MODIFICATION BULLETIN NO. ZB-001ISSUED ON August 26th, 1993

<b>Model</b>	<b>FAX220/240 (Australia version), Nashuatec F192L</b>	<b>Date of Modification</b>
<b>Modified Article</b>	Op-port Cover	<b>Execution Date</b>
<b>Reason for Modification</b>	<div> <input checked="" type="checkbox"/> Parts catalog correction <input type="checkbox"/> To meet standards (      ) <input type="checkbox"/> To facilitate assembly </div> <div> <input type="checkbox"/> Vender change <input type="checkbox"/> Part standardization <input type="checkbox"/> To improve reliability </div> <div> <input type="checkbox"/> Other </div> <p>Op-port covers have been changed to meet Australian PTT requirements.</p>	From the first of mass-production.

**MODIFICATION BULLETIN NO. ZB-005**

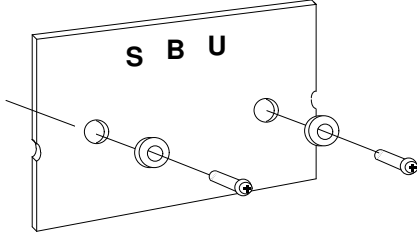
<b>Model</b>		<b>FAX240, Nashuatec F192L, α- InnFax</b>				Date of Modification	
<b>Modified Article</b>		Spring Clutch-Decurler, Decurler Bracket				<b>Execution Date</b>	
<b>Reason for Modification</b>		<input type="checkbox"/> Parts catalog correction <input type="checkbox"/> To meet standards (      ) <input type="checkbox"/> To facilitate assembly <input type="checkbox"/> Vender change <input type="checkbox"/> Part standardization <input checked="" type="checkbox"/> To improve reliability <input type="checkbox"/> Other <p>The decurler bracket and spring clutch have been changed to prevent the edge of the spring from scratching the thermal head surface. (Refer to the RTB ZB - 010 for more details).</p>				From the first of July production.	
Old Part No.	New Part No.	Description	Q'ty Used Old → New	Interchange- ability	Remarks	Parts Catalog	
						Index No.	Page
H5022107	H5022117	Spring Clutch - Deculer	1 → 1	X / O	(As a set)	114	7-2

H5022112	H5022116	Decurler Bracket	1 → 1	X / O	(As a set)	154	7-2
